Proposal #26: 1228-22-71, WISC 2021228
North-South Freeway
Capitol Drive to 2100' N of Hampton Ave.
IH-43
Milwaukee County

This is Addendum No.02, which provides for the following:

ADDENDUM NO. 02

1228-22-71

Addendum No. 02
ID 1228-22-71
Revised Sheet 442
April 9, 2021

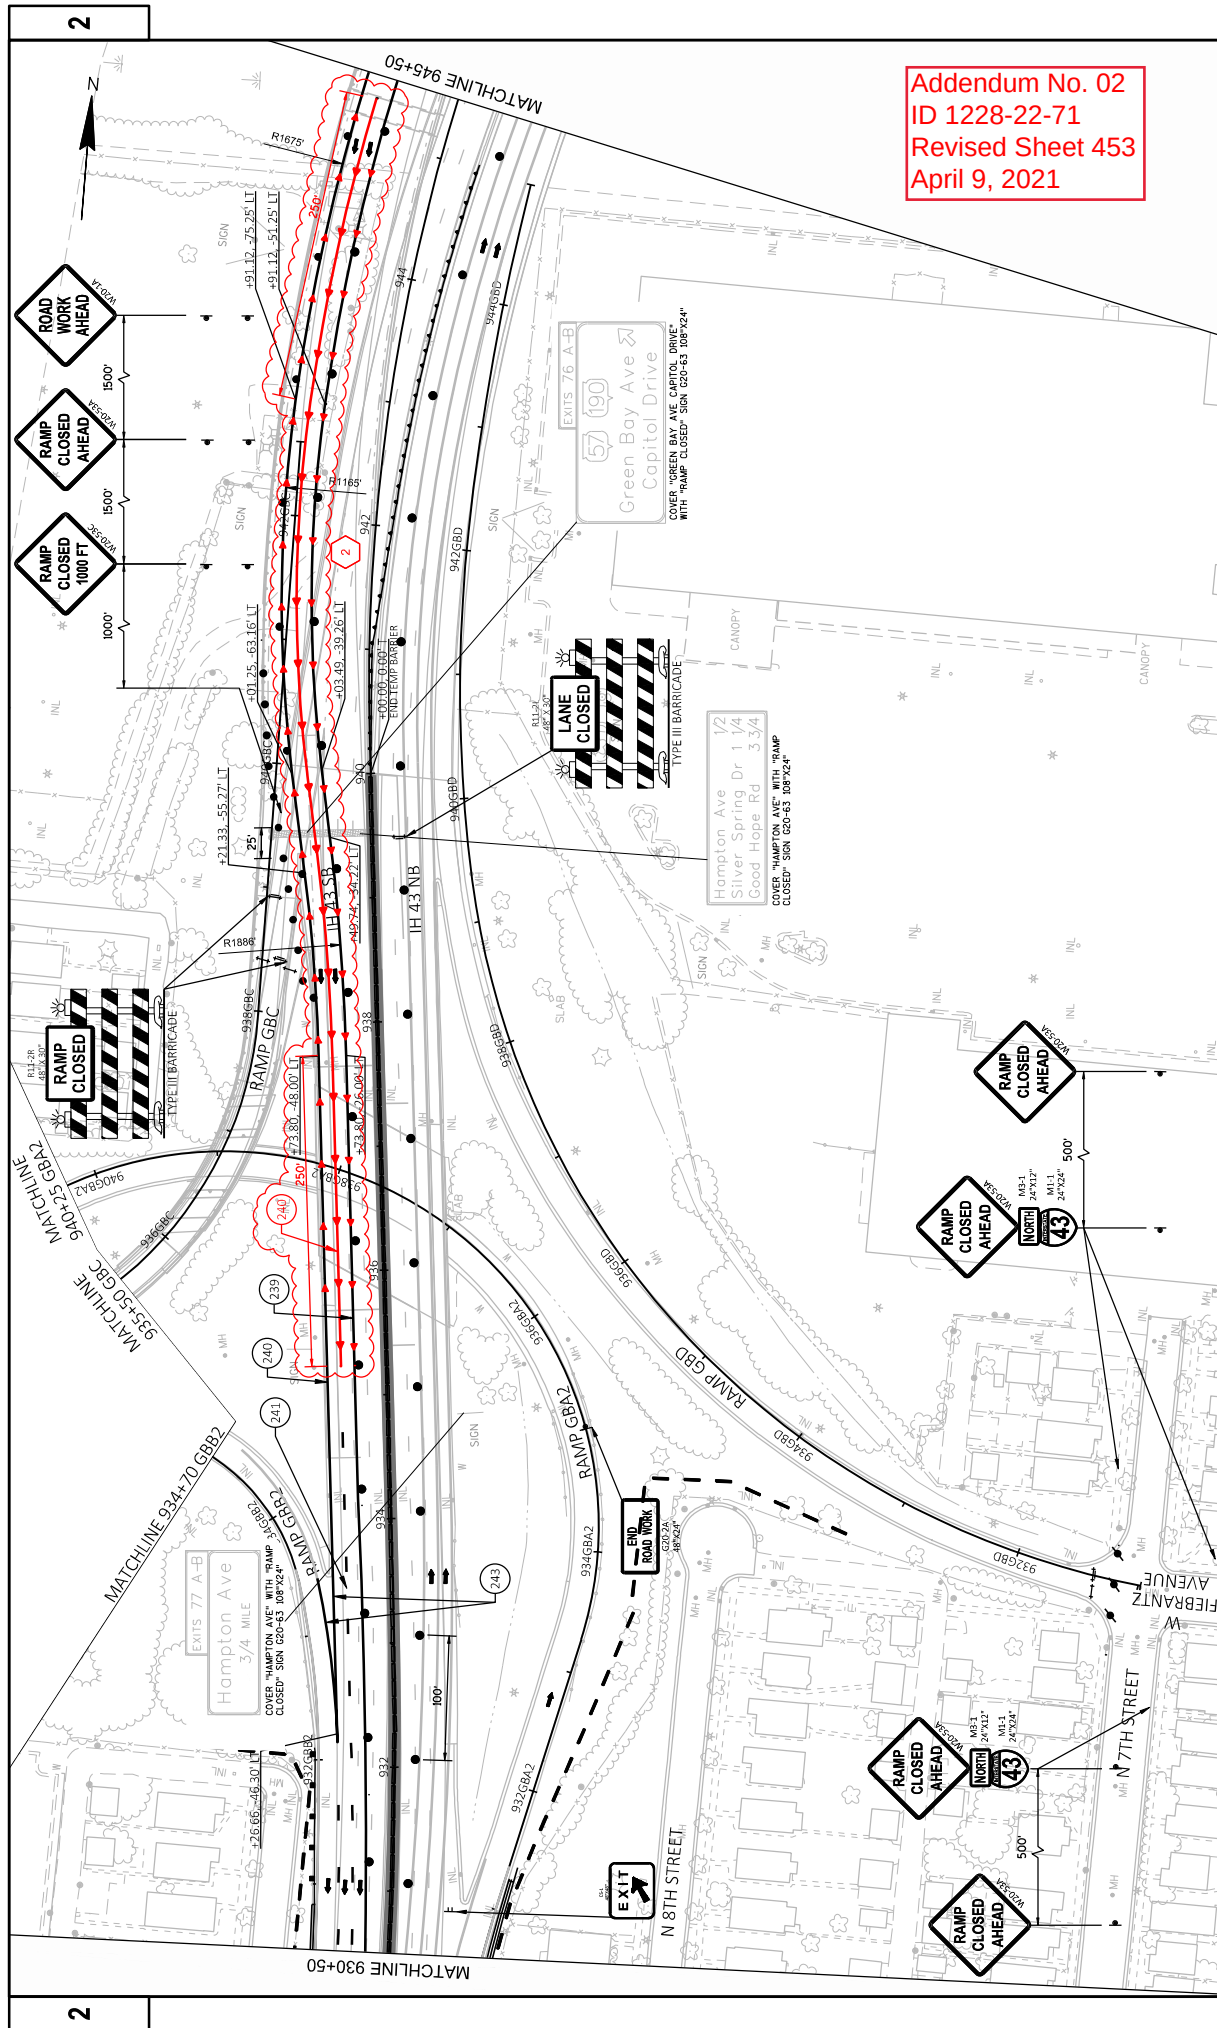
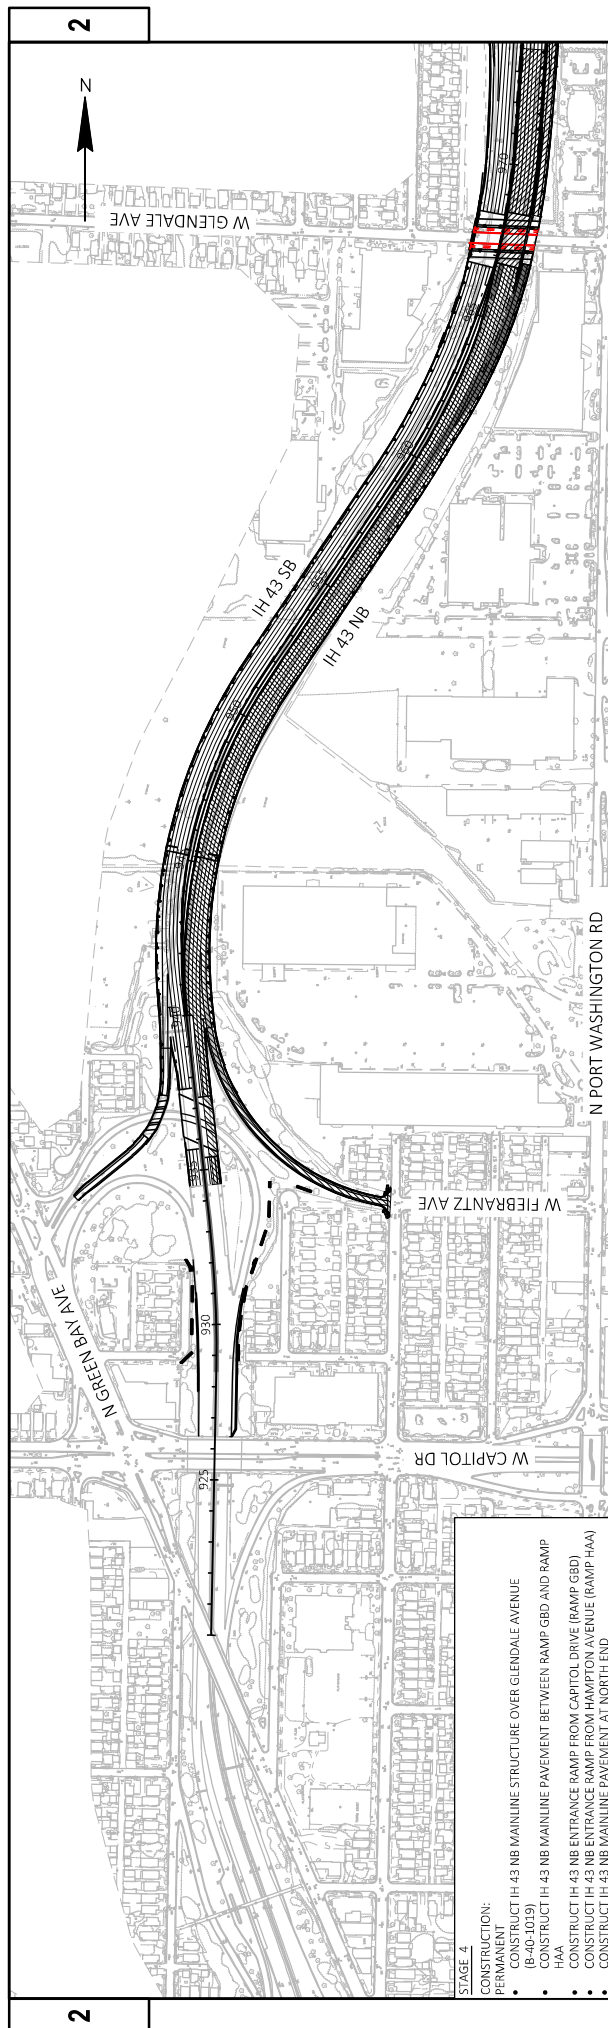
416, 420C	
425- 429, 431- 433, 433C	TC Stage 2D, Added Note for QWS
438- 439	TC Stage 3A, Added raised pavement markers and solid centerline
441- 442	TC Stage 3A, Added raised pavement markers and solid centerline
446C	TC Stage 3A, Added Note for QWS
453	TC Stage 3B, Added raised pavement markers and solid centerline
460C	TC Stage 3B, Added Note for QWS
474	TC Stage 4, Added Note for nighttime closure on Ramp GBA2
477- 478	TC Stage 4, Added raised pavement markers and solid centerline
483- 484	TC Stage 4, Added raised pavement markers and solid centerline
485C	TC Stage 4, Added raised pavement markers and Note for QWS
498C	TC Stage 5, Added Note for QWS
507- 509	Temporary Causeways, Updated typical width of causeway and removed fingers to Ramp HAB
566	Roadway MQ's, Updated earthwork table to include the Oak Leaf Pond, and corrected calculation error.
567- 568	Roadway MQ's, Updated quantities to be included in Ton item

Addendum No. 02
ID 1228-22-71
Added Sheet 509A
April 9, 2021

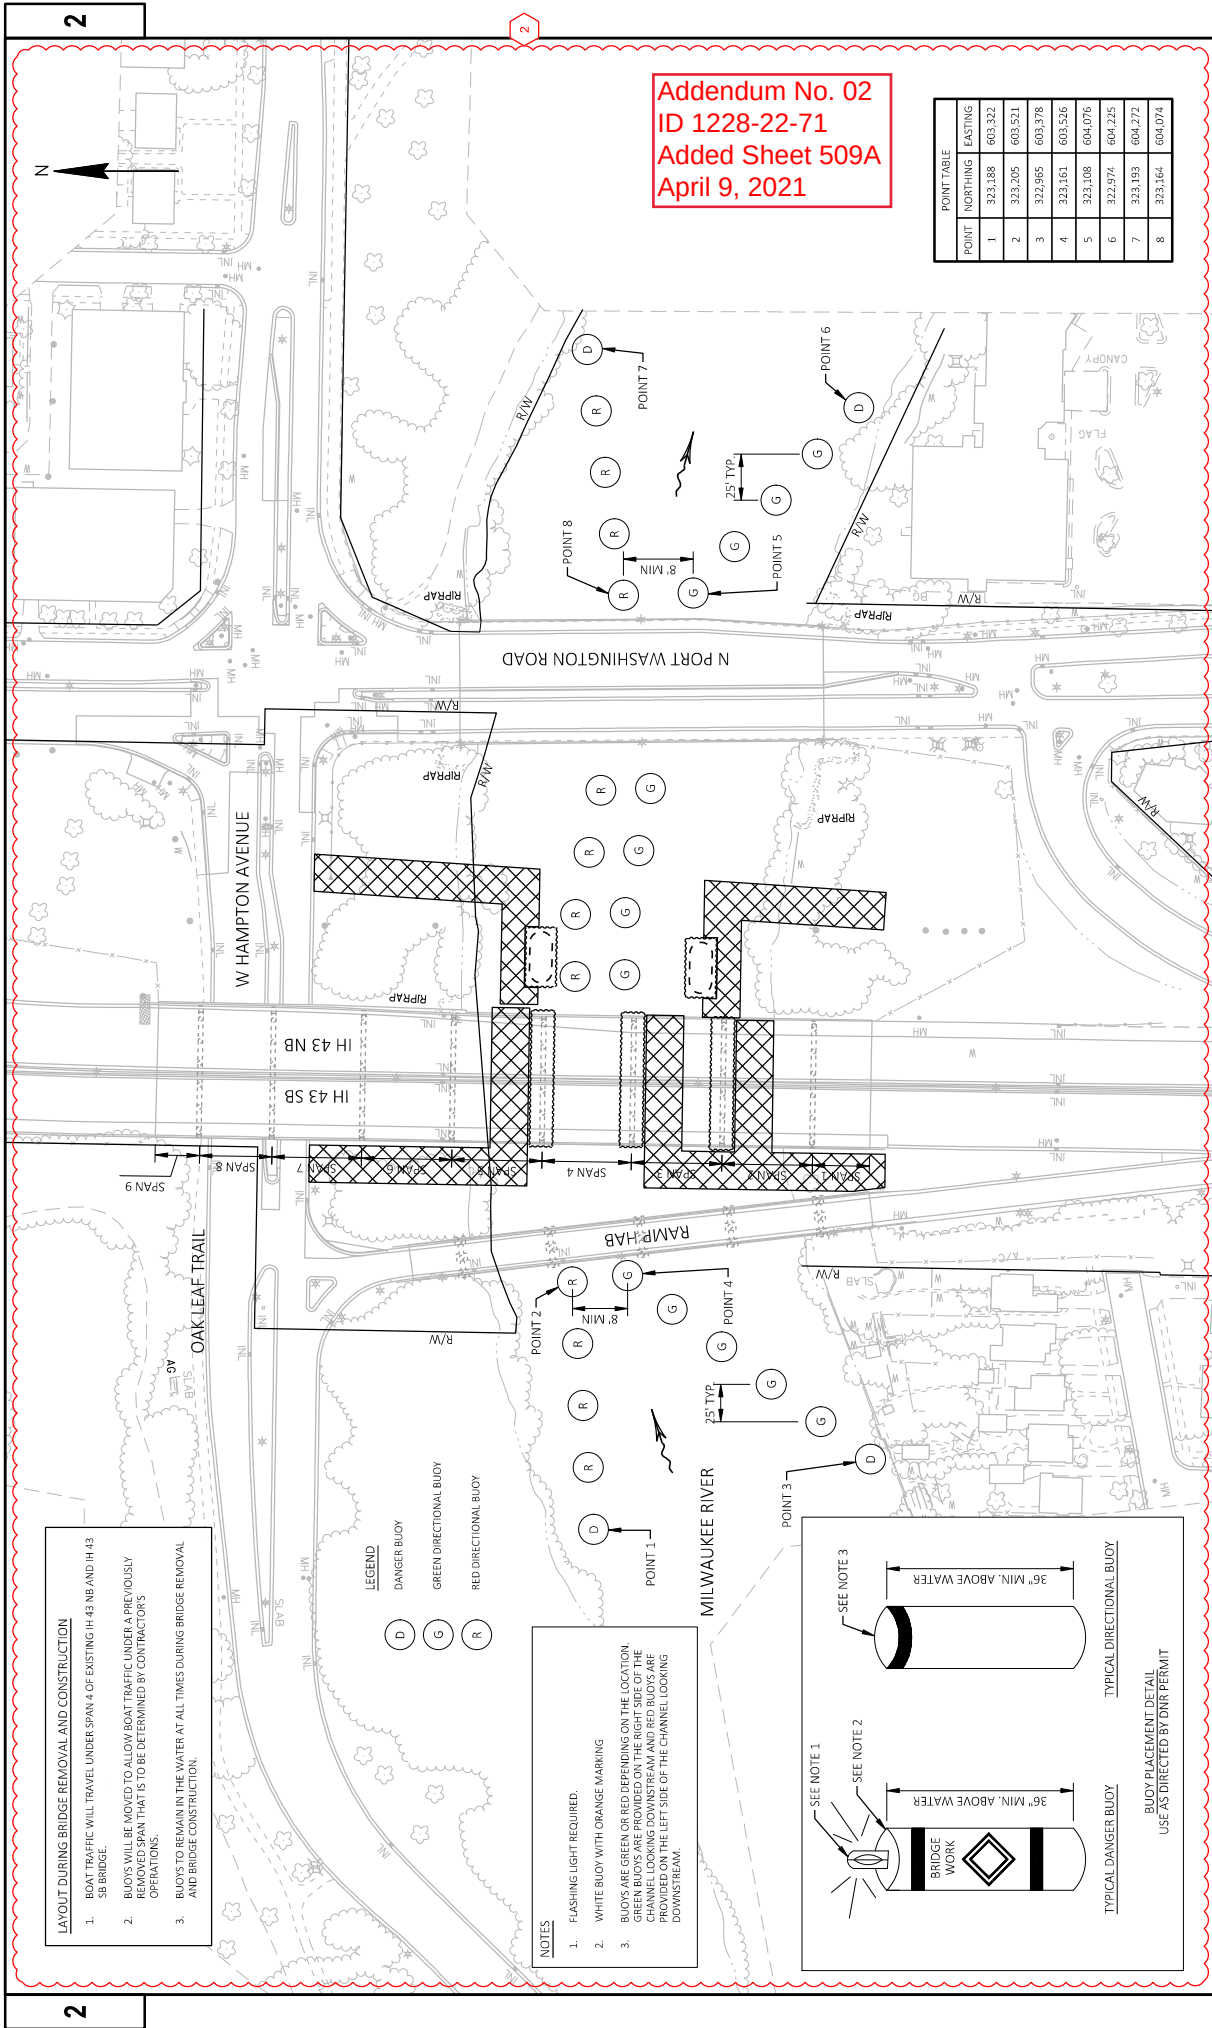
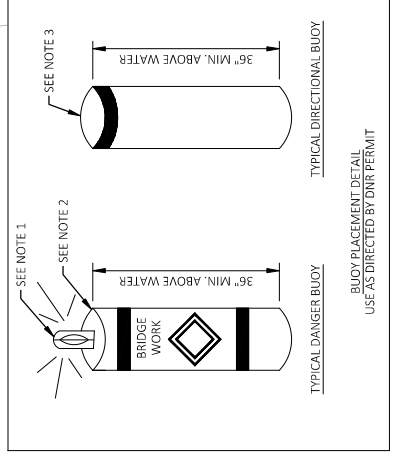
- LAYOUT DURING BRIDGE REMOVAL AND CONSTRUCTION**
1. BOAT TRAFFIC WILL TRAVEL UNDER SPAN 4 OF EXISTING IH 43 NB AND IH 43 SB BRIDGE.
 2. BUOYS WILL BE MOVED TO ALLOW BOAT TRAFFIC UNDER A PREVIOUSLY REMOVED SPAN THAT IS TO BE DETERMINED BY CONTRACTOR'S OPERATIONS.
 3. BUOYS TO REMAIN IN THE WATER AT ALL TIMES DURING BRIDGE REMOVAL AND BRIDGE CONSTRUCTION.

- NOTES**
1. FLASHING LIGHT REQUIRED.
 2. WHITE BUOY WITH ORANGE MARKING
 3. BUOYS ARE GREEN OR RED DEPENDING ON THE LOCATION. GREEN BUOYS ARE PROVIDED ON THE RIGHT SIDE OF THE CHANNEL LOOKING DOWNSTREAM AND RED BUOYS ARE PROVIDED ON THE LEFT SIDE OF THE CHANNEL LOOKING DOWNSTREAM.

Place buoys as shown on the plan and as approved by the engineer. Place waterway buoys in the water prior to any in-stream work (demolition or construction), and keep in place until such work is completed and all in-water obstructions such as falsework are completely removed. Locations of navigation ways may need to be adjusted from that shown in the plans as directed by the engineer.
